# NEW WINDOW WALL DOOR PROFILE NKWWR4WP - AB204

January 2019  
Technical Bulletin

## INTRODUCING THE NEW AND IMPROVED WINDOW WALL DOOR PROFILE - NKWWR4WP - AB204

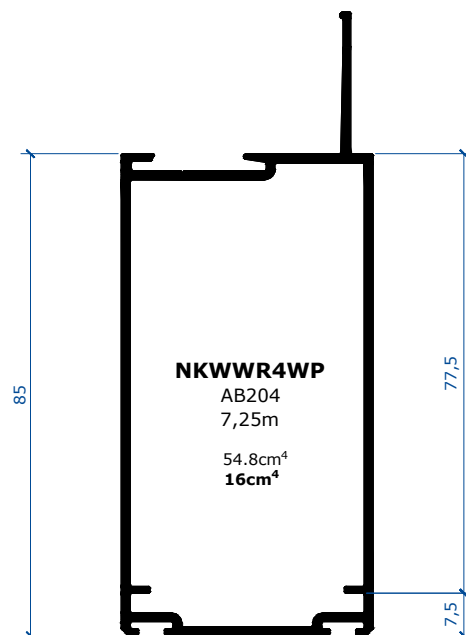
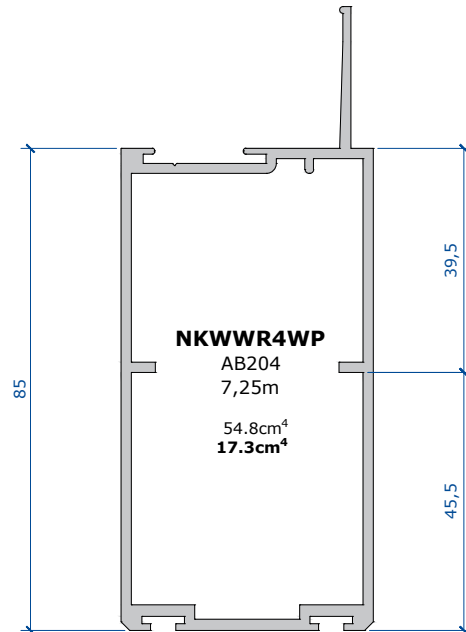
At HBS we are continuously striving to develop our products and in so doing we have improved to the Window Wall profile NKWWR4WP-AB204.

- 19% lighter than the old version.
- Slot for flat bar fixing of hinges and locks.
- Inertia remains a useful  $16\text{cm}^4$  in the wind direction.
- Interchangeable with old version.
